ADDENDUM NO. 2

Project: Columbia Hall Parking Lot Renovation
Project Number: H27-Z201

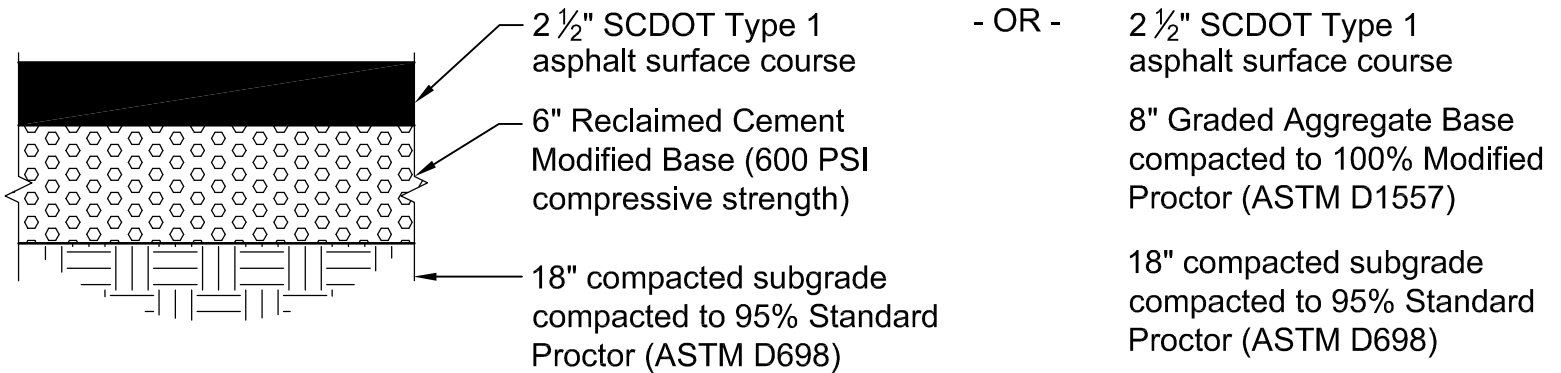
The following items were changed:

-The pavement sections have been revised to include the option of using GABC or cement stabilized base. All excavated material is unclassified and must be removed from the site and disposed of in a legal manner at the contractor's expense.
